Delegated Report

Householder Planning Application

Planning Application No: 20220344

Description: Erection of a single storey rear extension and a two storey side extension to provide additional residential accommodation and modifications to the entrance porch and front bay window.

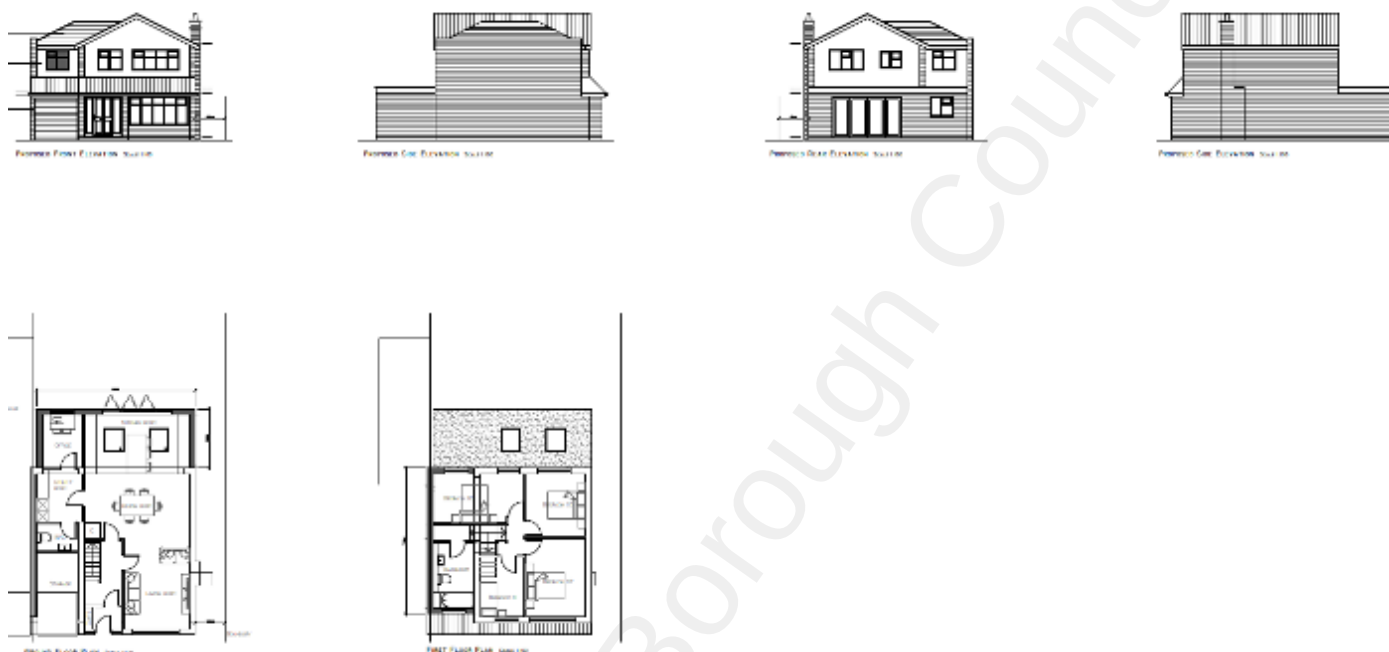
The single storey rear extension will project 3m from the rear elevation and span 8m across. The extension will be finished with a flat roof which will have a maximum height of 2.7m and include two roof lights. There will also be a bifold door in the rear elevation and a window. The window will serve a study room and the bifold will serve the new kitchen.

The two storey side extension will project approx. 2.3m from the southern elevation and span approx. 7.3m with a maximum height of approx. 6m. The extension will be set below the main roof and behind the front elevation. The extension will include a flat roof element and will be hipped on the three edges, there will

also be a parapet all on the southern wall. There will be a window in the first floor front and rear elevation which will serve a bathroom and a bedroom. At ground floor level there will be a garage door to allow for access to the storage area.

To the front of the extension there will be a monopitch roof going across and the front elevation at ground floor level will be brought in line with the furthest projection of the existing bay window.

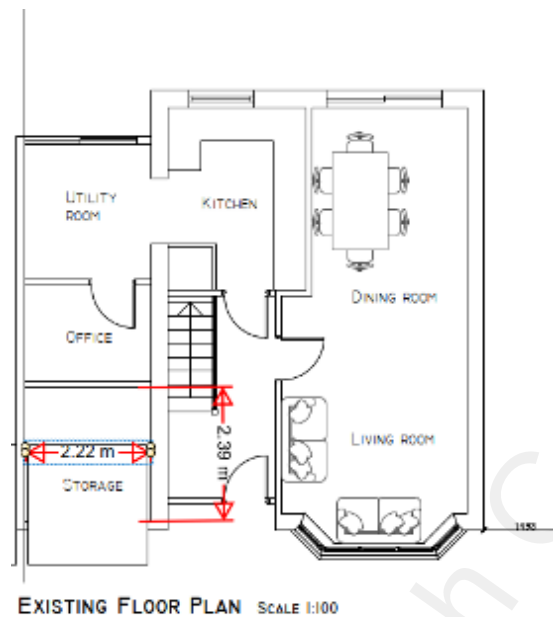
The proposal is not liable to impact the privacy of the adjoining property known as No.66 Biddenden way as there are no windows proposed in the flank elevation. However the bathroom will be moved from the rear of the property to the front of the property and so a condition will be imposed to ensure the window serving this room is obscure glazed and top hung.

In terms of light and outlook the proposal is not liable to result in any material harm due to the path of the sun and the scale of the development. There is a window in the flank elevation of this property which will face the two storey side extension, however this window is deemed to serve a hall way and not a habitable room.
